Joint Committee on Infrastructure & Police Commission

Meeting of June 25, 2025

City of Nashua Police Department - 9 Riverside Building Assessment

SI-04 Existing Catch Basin Drain Modification and Added New Site Drainage Structure

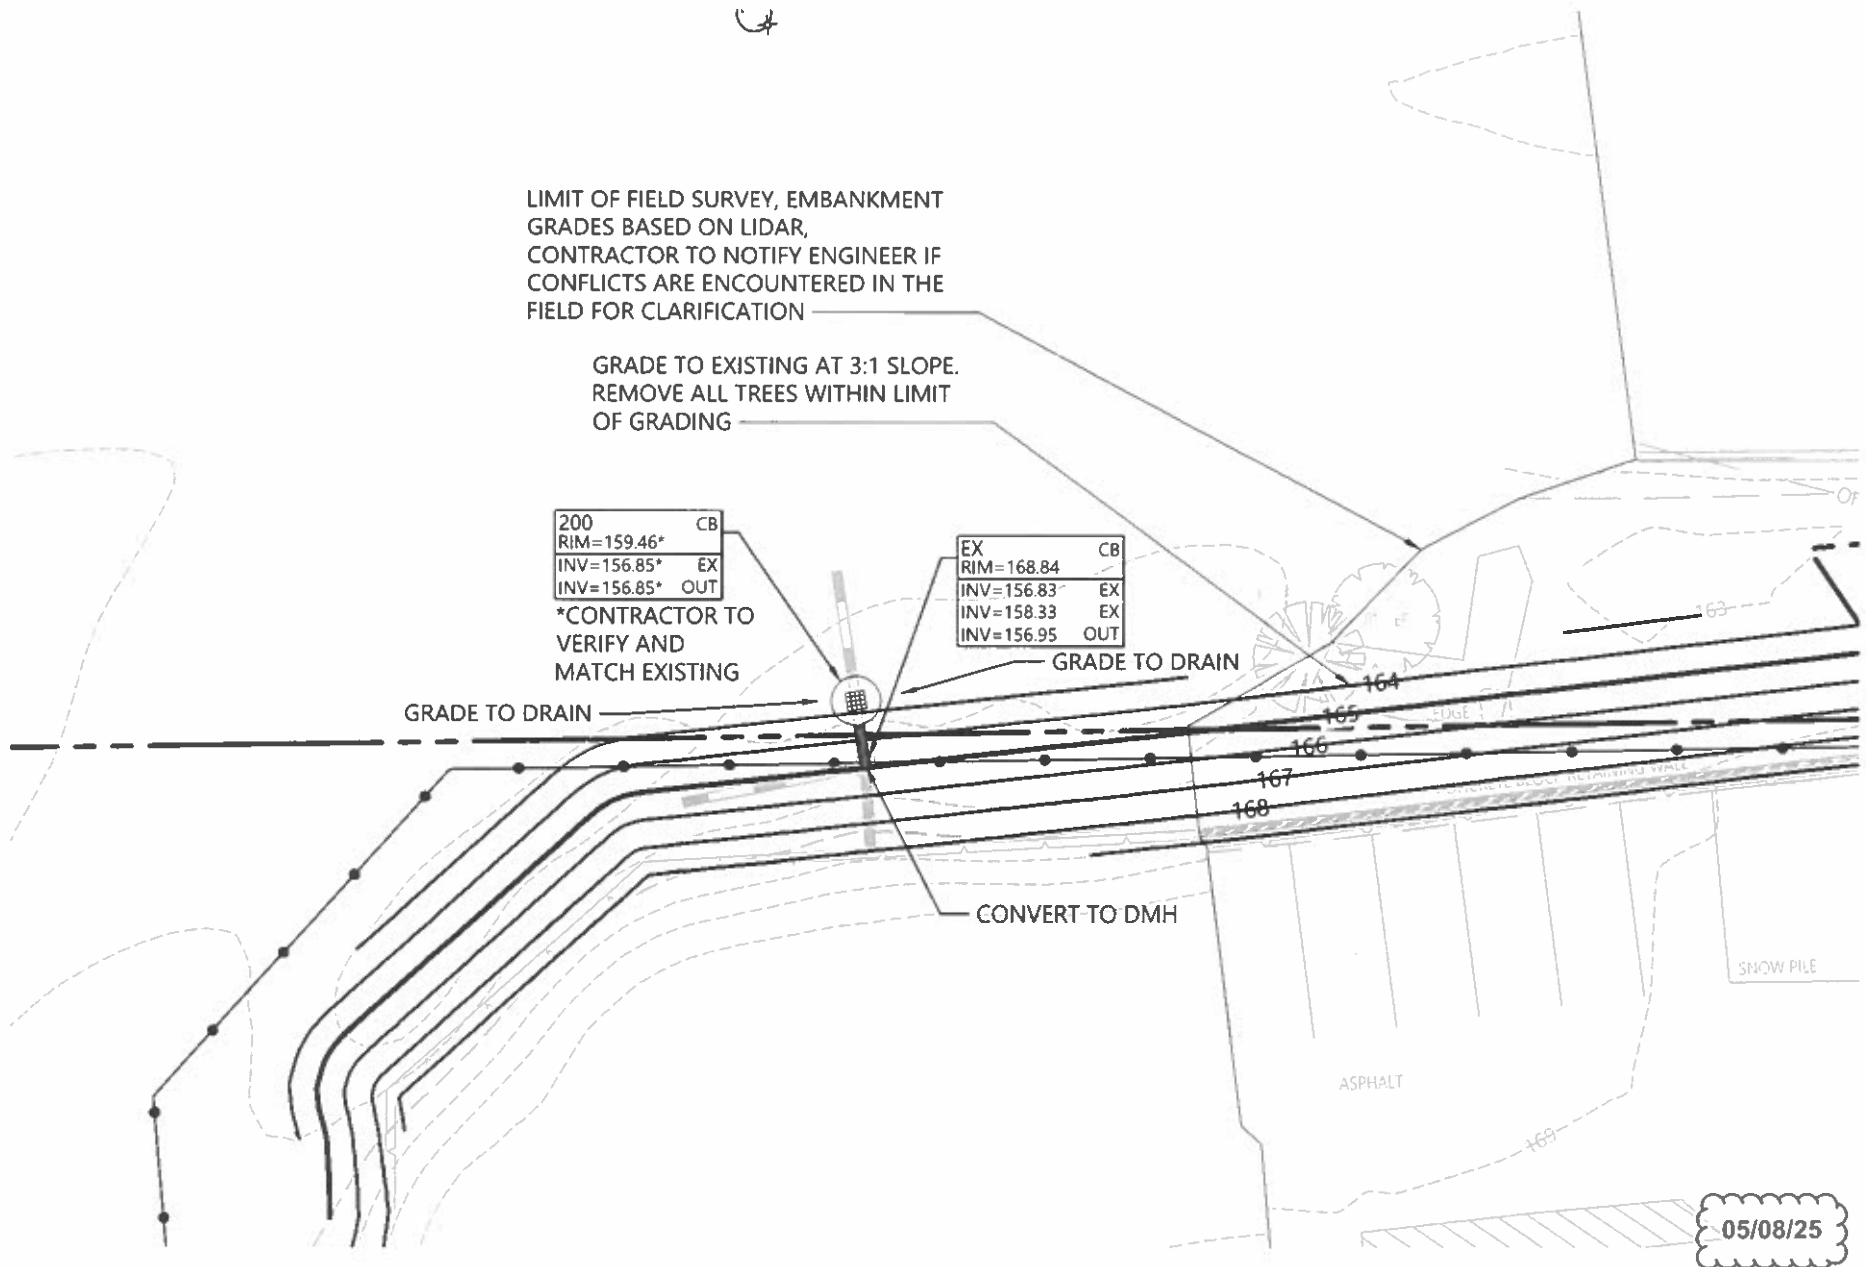
SCOPE OF WORK: An existing catch basin was discovered adjacent to Riverside St that was not shown on the Contract Documents. As it is located in an area that is to receive new grading, an RFI was submitted requesting clarification on how to proceed. The response came back and Supplemental Instruction SI-04 was issued, instructing to convert the existing catch basin to a drain manhole, install a new catch basin away from the slope and grade to the new drain.

Costs for this change are for labor and materials to convert the existing CB into a DMH, install a new CB, connect the two structures and grade to them.

RFI #025 Added Handhole for Remove Light Pole

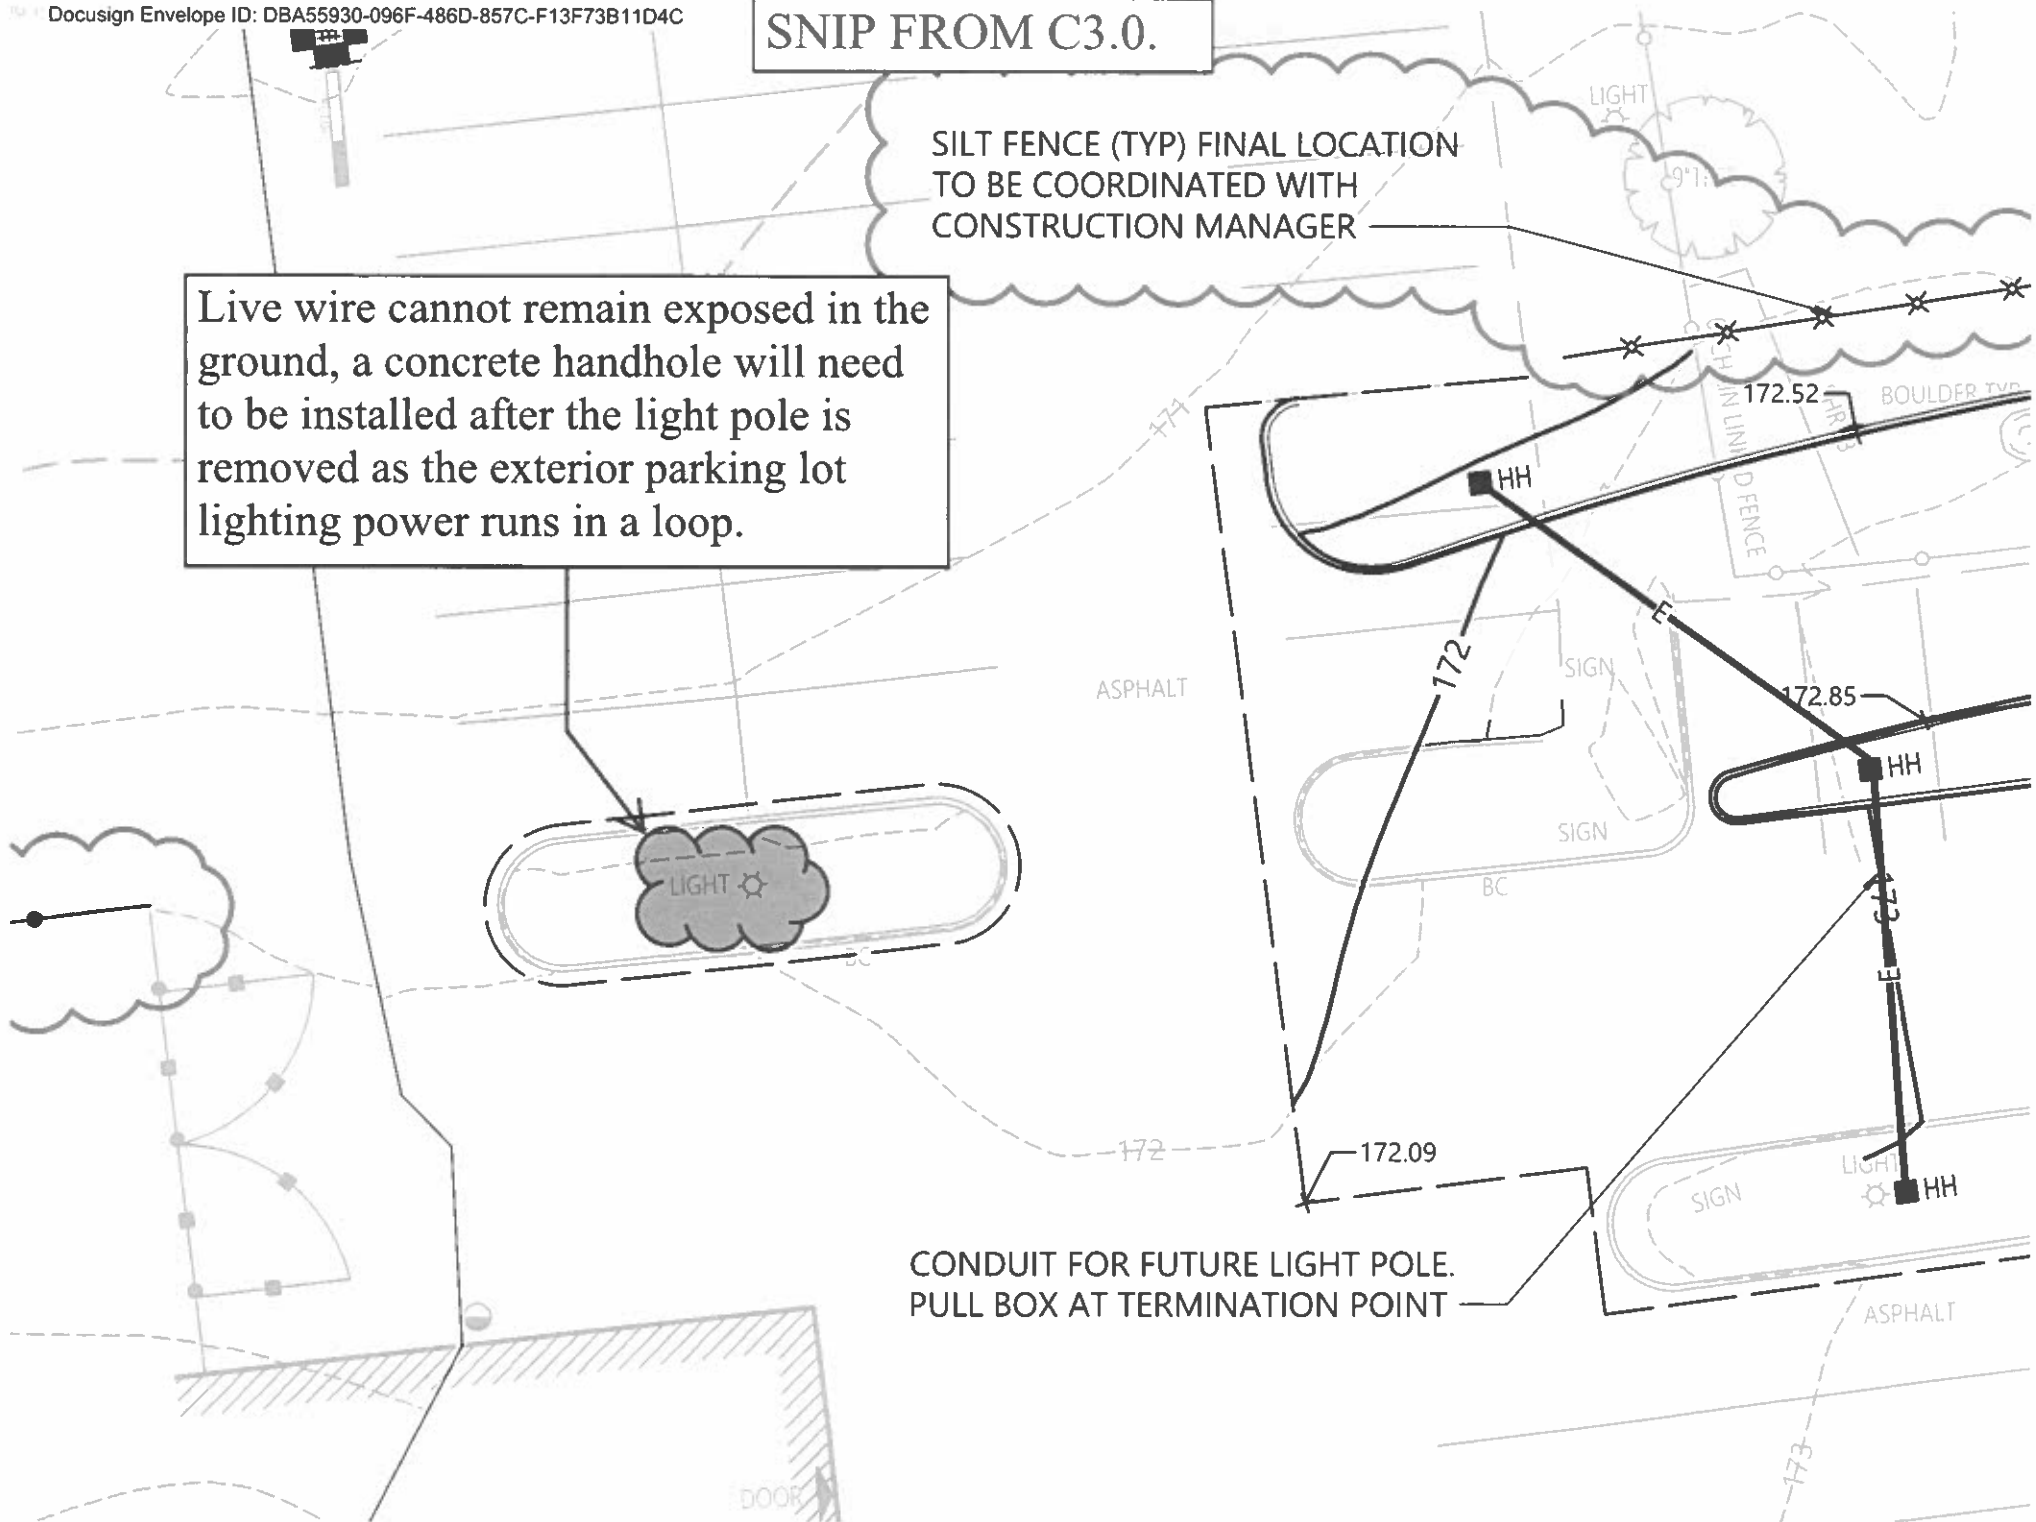
Question					
Date Required: 05/23/2025					
At the plan west island and light pole that is called to be removed, a handhole is required as live wire cannot be left exposed in the ground. The wire must remain live because the light poles in the PD parking lot are all on 1 loop, thus disconnecting the 1 would be disconnecting them all. As a result, a concrete handhole needs to be installed at this location. Please confirm installing a concrete handhole at the location shown in the attached sketch is acceptable.					
Suggestion					
Cost Impact		Cost Amount		Schedule Impact	
YES				No	
No Suggestion Provided					
Notes

- Minimum requirements shall be that all sections of the product shall be designed for HS-20 loading.
- Submit a shop drawing for a product for review.

Live wire cannot remain exposed in the ground, a concrete handhole will need to be installed after the light pole is removed as the exterior parking lot lighting power runs in a loop.

**SI-01 - EXISTING WALL MODIFICATIONS AT DOORWAY
#RS-110**

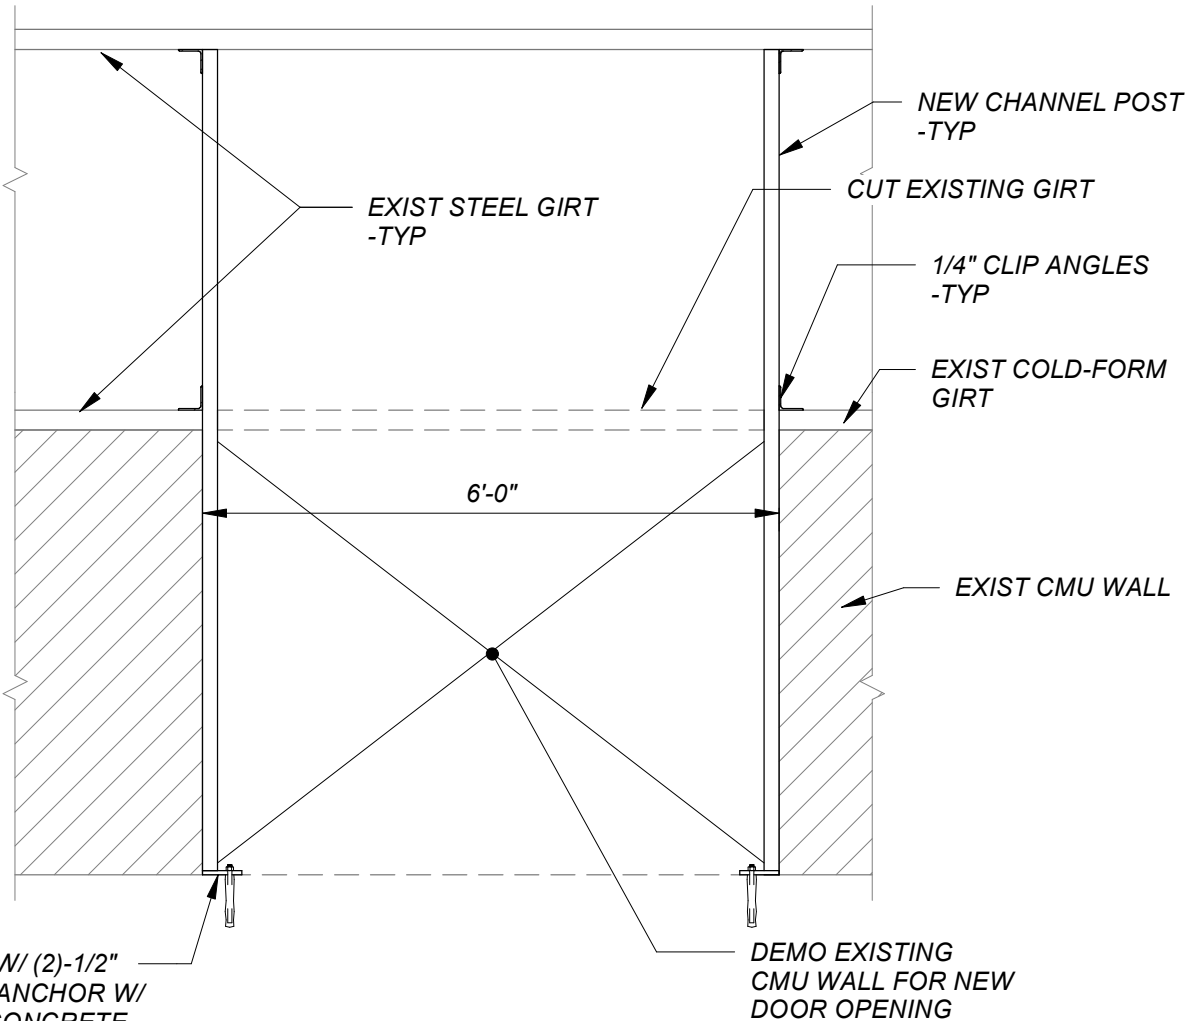
Please find attached sketches identifying solutions to unforeseen uncovered existing wall and wall framing conditions at proposed new doorway RS110 to the new NTS Data Room.

New structural framing and adjusting of new stud walls locations will be necessary.

1 ELECTRICAL OVERALL UTILITY GRADING DRAINAGE - SITE PLAN
3/4" = 1'-0"

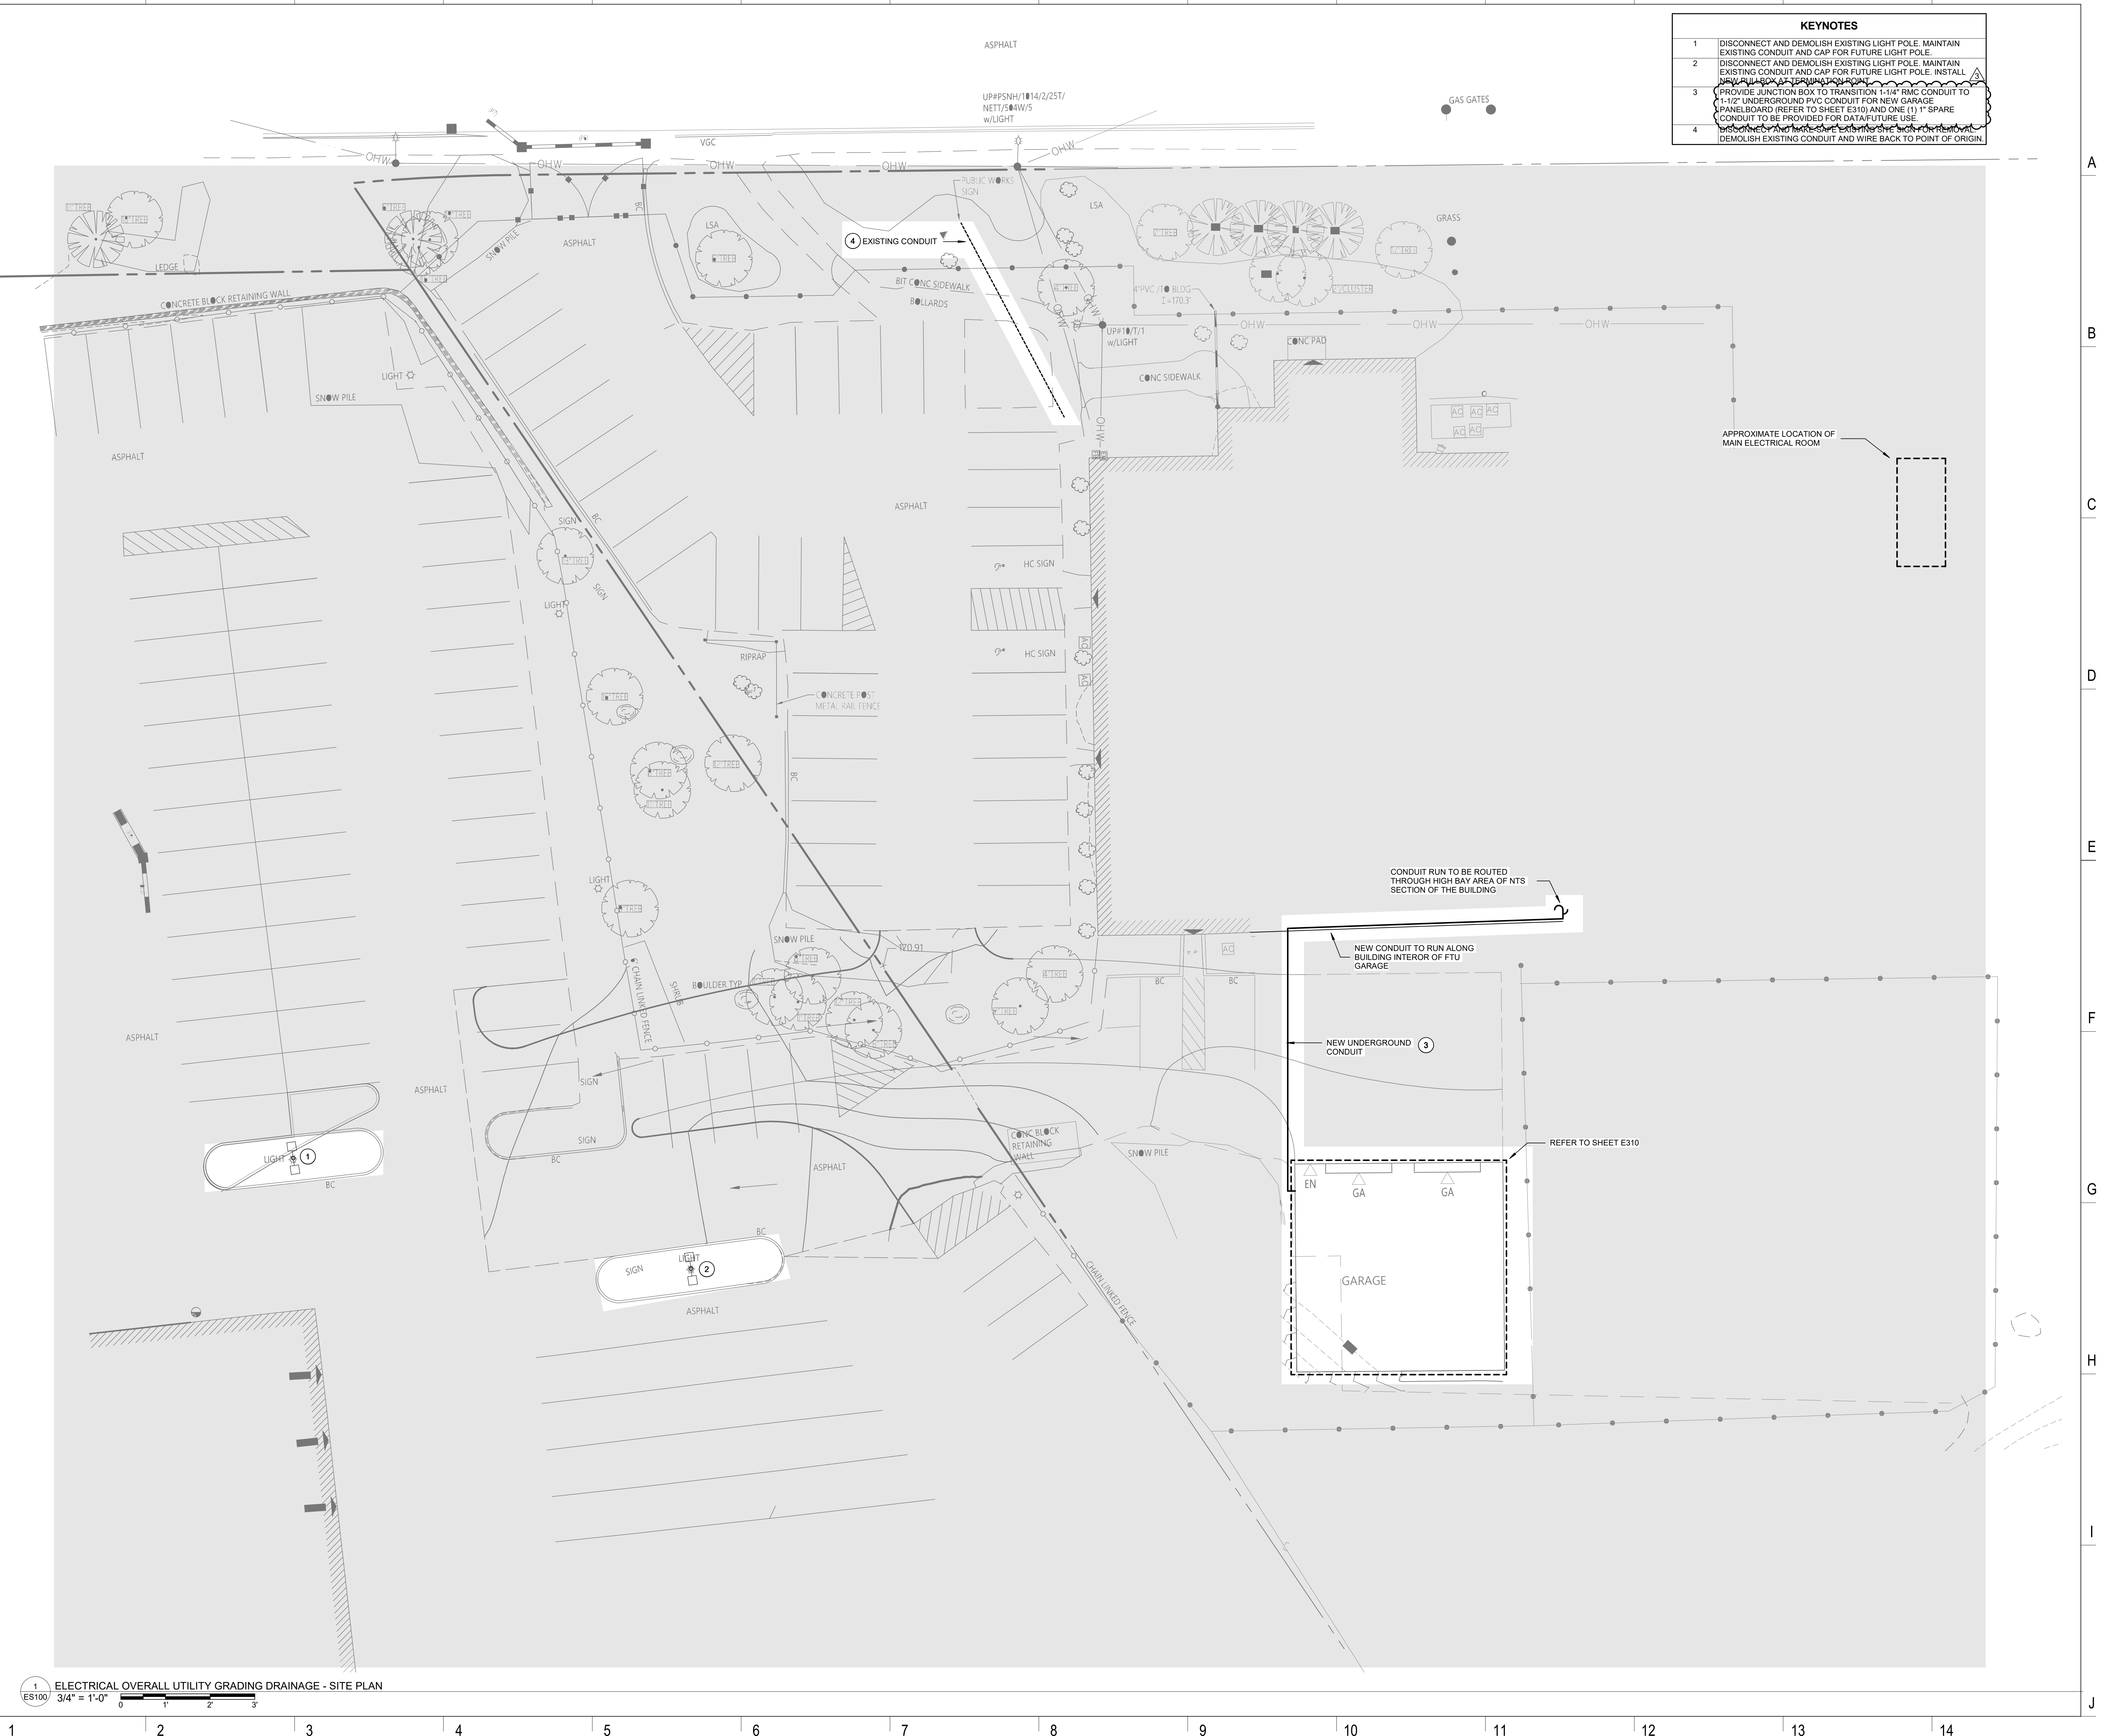
Drawing ES-1 - Site Plan - Conduits from MDP-1 to new Garage Panel PPG will change from 1-1/4" to 1-1/2" Conduits to accomodate (4) #1, (1)#6G. Conduits will change over to PVC exiting the existing building to Garage. Previously installed 1-1/4" emt conduits will be demoed and replaced with 1-1/2" EMT.
